**PIPE ZONE BEDDING AND BACKFILL**  
**STANDARD PLAN B-55.20-02**

**SUPPLEMENTAL TO STANDARD PLAN  
B-55.20-02**

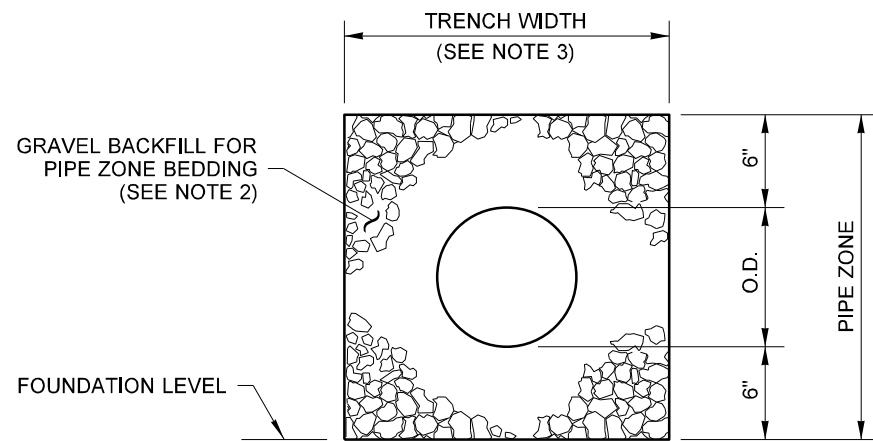
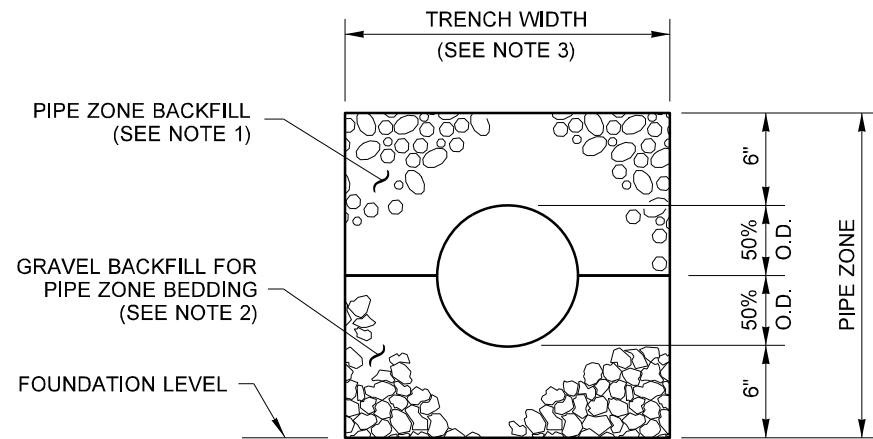
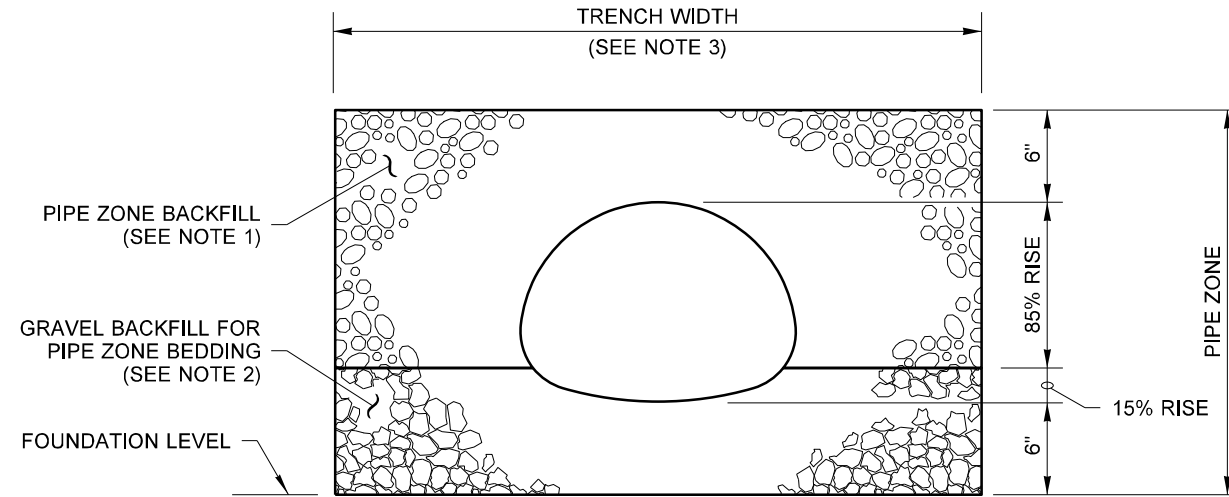
**Modify the Standard Plan as follows:**

Notes:

1. Delete Notes 1. and 2.

2. Pipe Zone Backfill and Pipe Zone Bedding shall be CSTC.
